ADDENDUM NO. 2

Greater New Haven Water Pollution Control Authority

2016 Collection System Assessment and Rehabilitation –
Chapel Street Project
Project No. SSR 2016-01

SSR 2016-01 : Schedule of Sewers to be Cleaned, CCTV Inspected and Rehabilitated

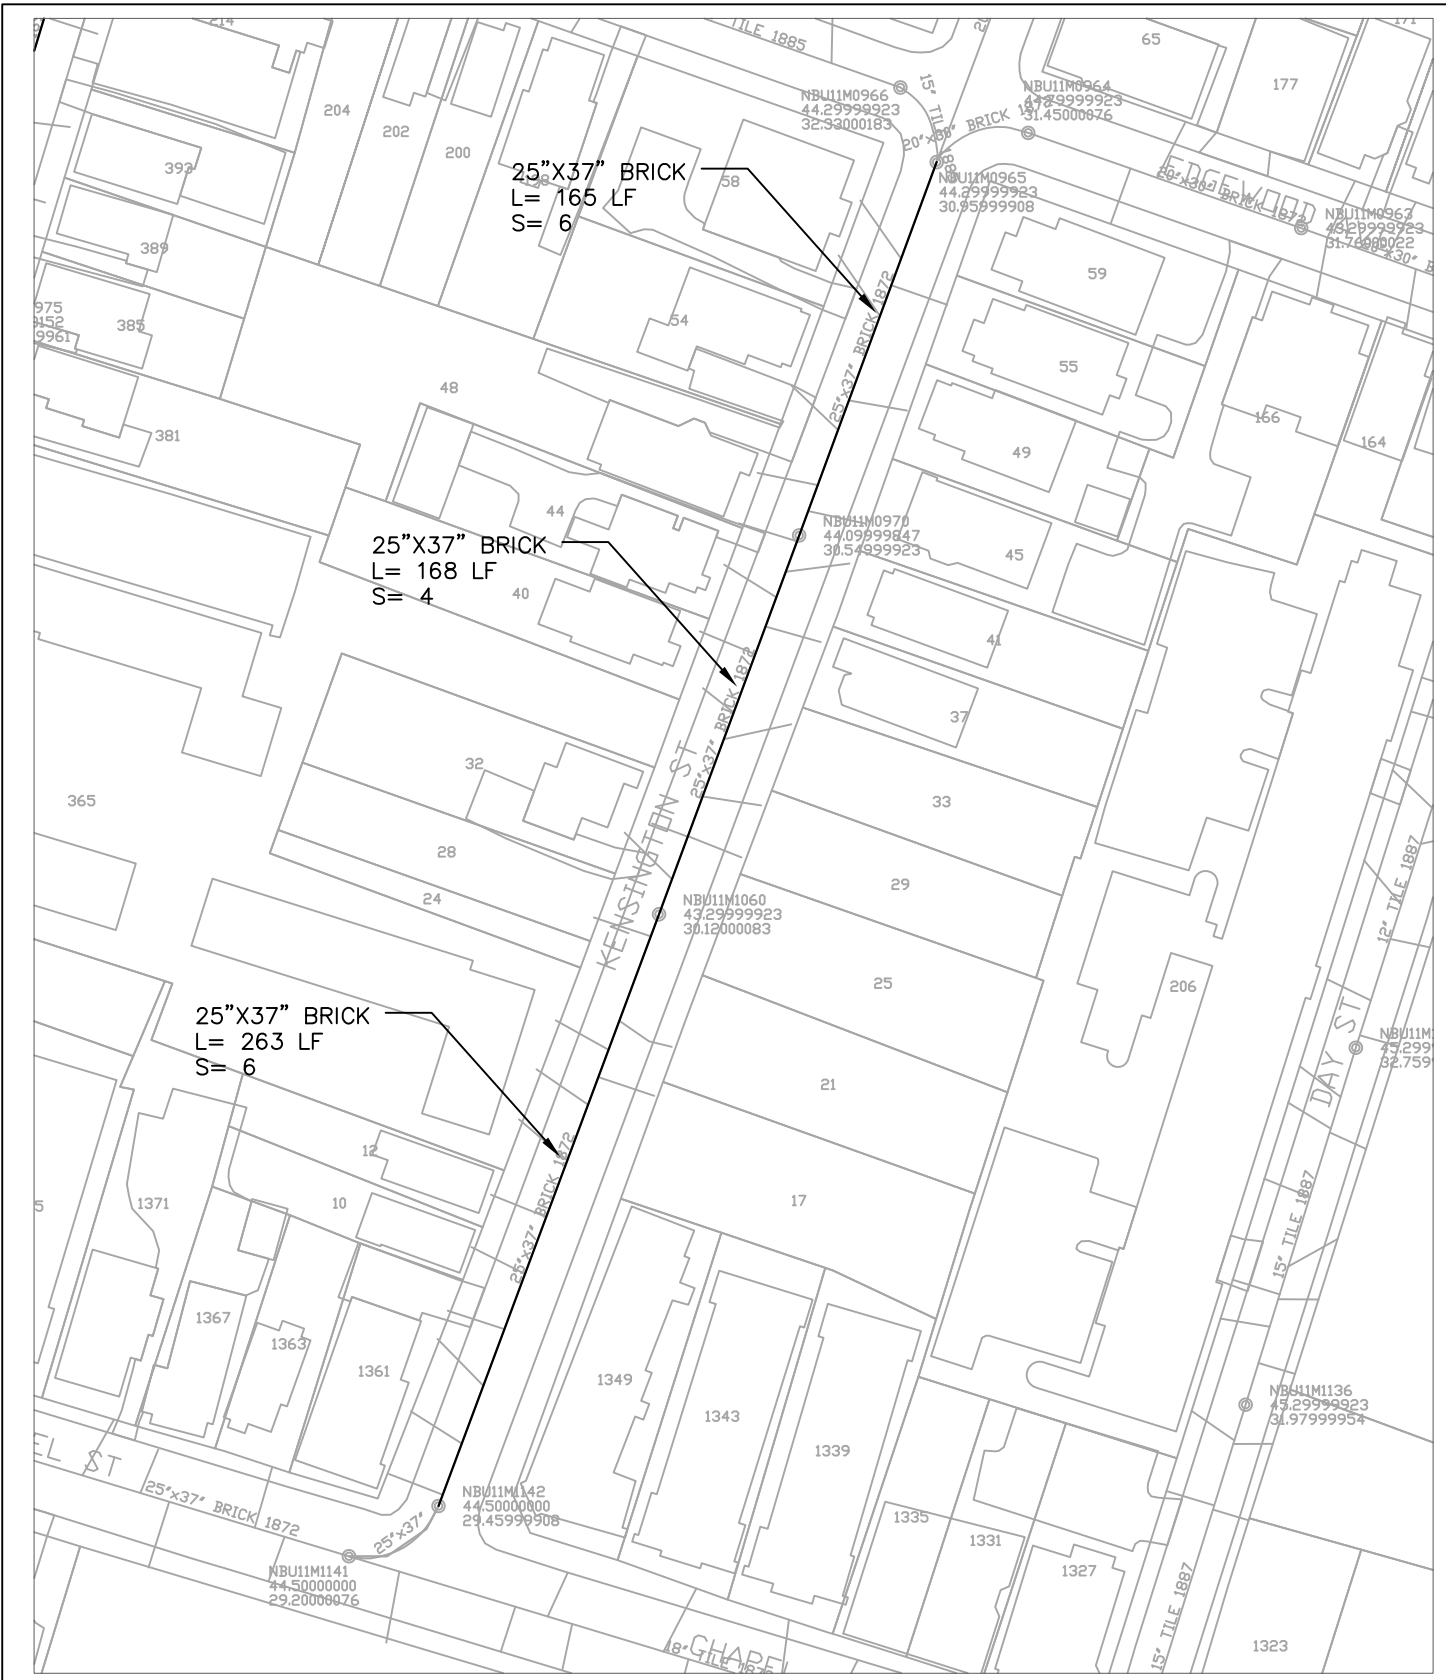
The size of the existing pipe on Kensington Street is 25"x37" Brick. GNHWPCA has revised the project's bid items and quantities as shown on the enclosed Schedule of Bid Items (Revised 2/24/2016). Pipe segment between manholes NBU11M0964 and NBU11M0965 (43 LF) has been removed from the contract.

2. Modifications to Appendix D. Schedule of Sewers to be Rehabilitated

Replace existing schedule with the enclosed schedule revised 2/24/2016.
